Ref: **CPP Project 18496**

### Portside Build to Rent wind assessment following proposed changes

Figure 1: Proposed changes to the development (5-point Projects, 2025)

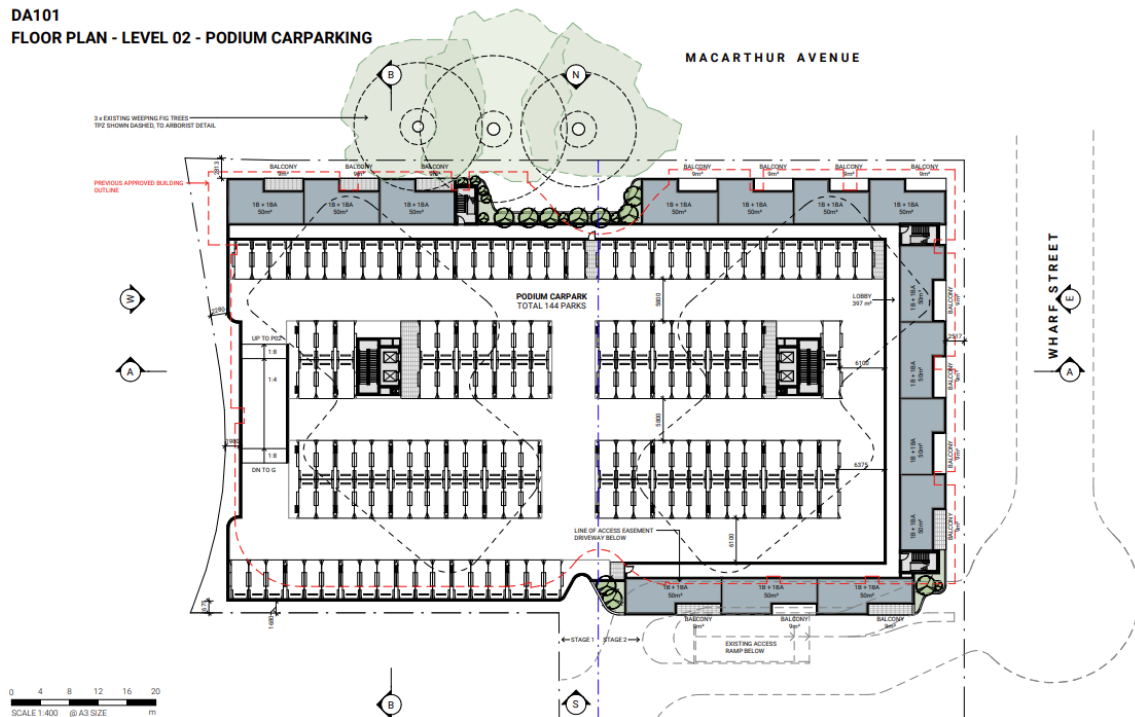
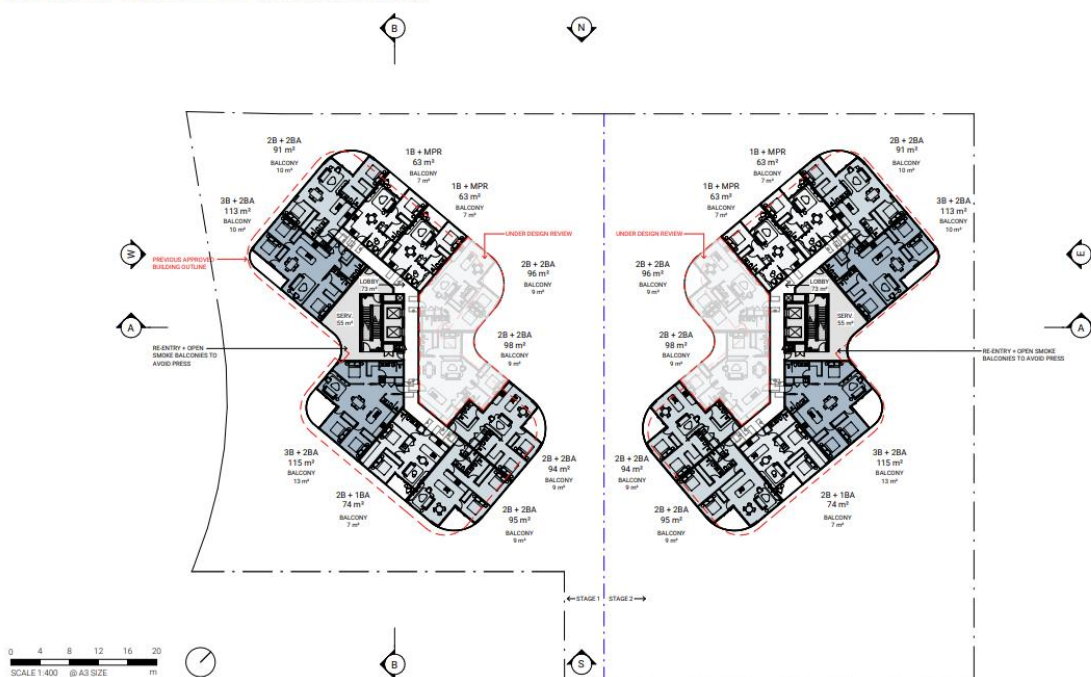
CPP have previously completed a qualitative assessment for the Portside Build to Rent development in Hamilton, Brisbane [1]. This letter addresses the applicability of these results following proposed changes to the development outlined in the set of drawings received by CPP on 25<sup>th</sup> July 2025, shown in Figure 1.

Figure 2: Proposed ground-level floor plan (5-point Projects, 2025)

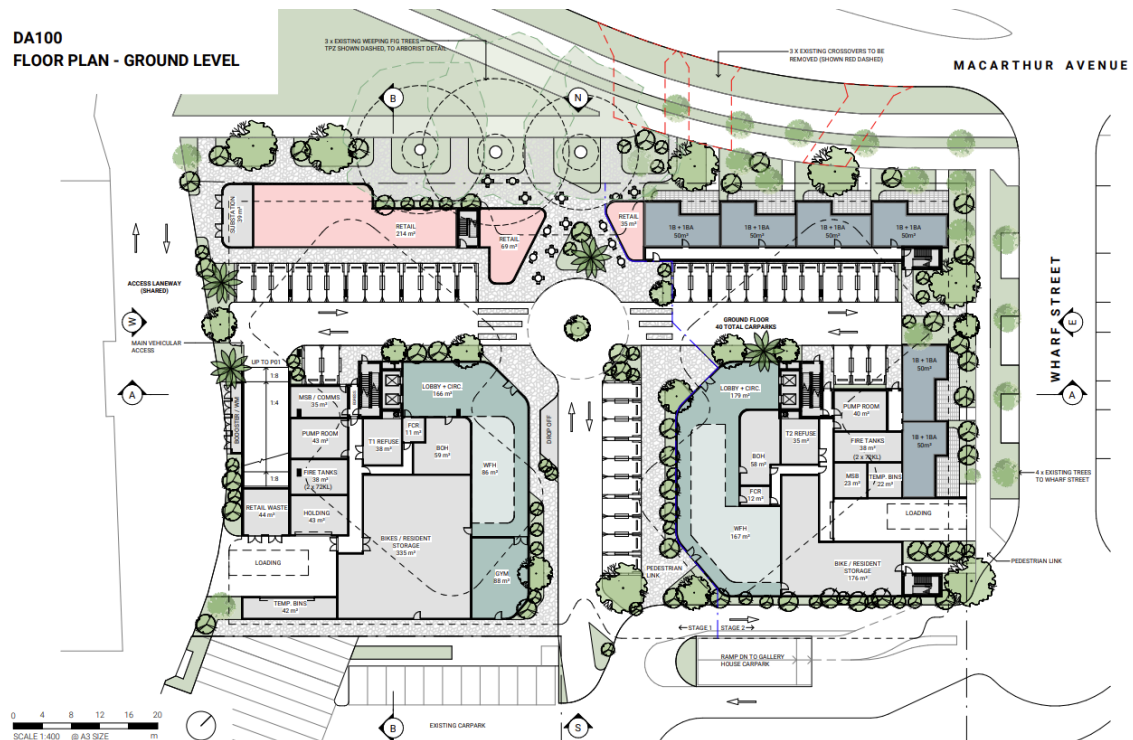
The proposed design changes, Figure 2, remove the external doors which were previously present in the crosswalk link area on the ground level (underneath the podium) and also introduce openings on the east and west side of the ground level. These changes are expected to cause increased wind speeds for the northern portion of the arcade during prevailing winds from the north to north-east due to pressure-driven flow. As this area may be used for outdoor dining (depending on the tenants), mitigation measures would be recommended. For winds from the north to north-east, positive pressures on the north side of the development would effectively be connected by these openings to negative pressures on the south, and particularly the east and west side of the development. While not as prevalent as south-westerly winds, winds from the north-north-east occur regularly in Brisbane. Higher wind speeds are relatively frequent from this direction, along with the west.

This wind-induced pressure distribution around the building, combined with the chamfered north corridor is likely to generate a strong breeze through the north opening which is then channelled out through the east and west openings. Wind conditions in this area are expected be consistent with a Pedestrian Walking comfort rating based on the Lawson wind comfort criteria. For longer-term stationary activities, a milder rating (Pedestrian Sitting or Outdoor Dining) would generally be preferable. However, for warmer climates, it can sometimes be desirable to have higher wind speeds to provide relief from the heat. For Brisbane specifically, north to north-easterly winds which drive the increased wind speeds are more prevalent during the summer months than winter. While this may assist with the comfort level experienced by pedestrians to an extent, mitigation measures would still be recommended for longer term stationary activities. These can be achieved by positioning outdoor dining areas to the north of the retail spaces, where milder wind conditions would be available, away from the northern opening. The rest of the ground level area, which encompasses the majority of the space, appears to be dedicated to transit. The wind conditions in this area are generally expected to be suitable for the intended purpose of this space.
